V2500-A5 SERIES PROPULSION SYSTEM NON-MODIFICATION SERVICE BULLETIN

This document transmits Revision 2 to Service Bulletin EV2500-72-0474

V2500-ENG-72-0474

NON - MODIFICATION SERVICE BULLETIN - HIGH PRESSURE TURBINE (HPT) STAGE 2 HUB
INSPECTION

HPT STAGE 2 ROTOR MARKING LOCATION
Figure 1

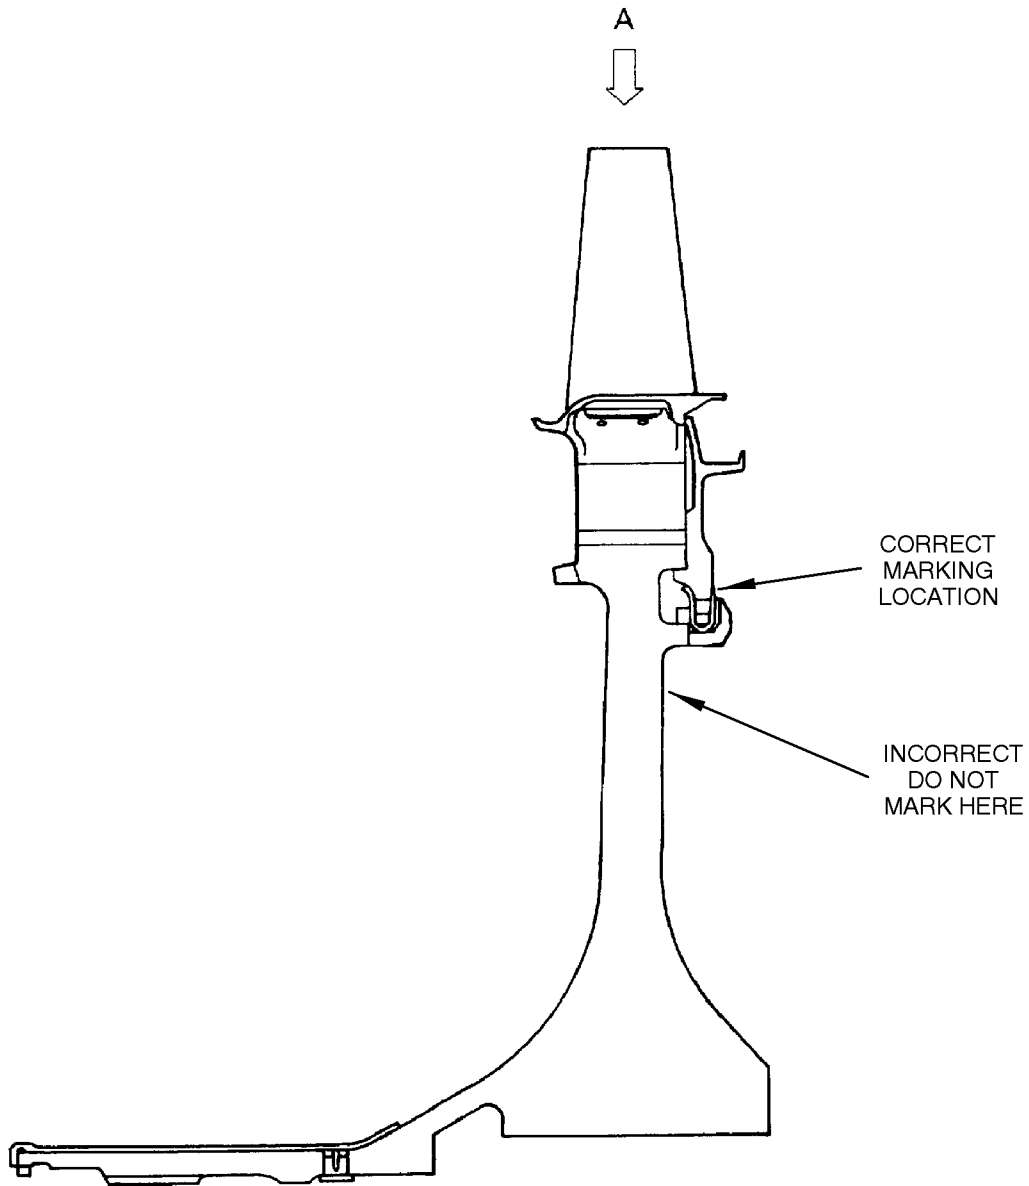
- R (1) Problem: The HPT stage 2 Hub P/N 2A4802 Serial Number PKLBEU5303 in engine
serial number V11565 may have been incorrectly marked during assembly.
The HPT stage 2 rotor assembly should be identified on the stage 2 blade
retaining plate. The assembly number may have been improperly marked on
R the web of the HPT stage 2 hub.

Repair any HPT stage 2 hub that is not marked correctly.

- R (1) Action per this NMSB is no longer required. The requirements for
R inspection the HPT stage 2 hub has been incorporated into the Engine
R Manual in Subtask 72-00-45-220-211, Subtask 72-45-30-220-088 and Subtask
R 72-45-31-220-113.
- (2) Recording Instructions
- R (a) A record of accomplishment is not required.
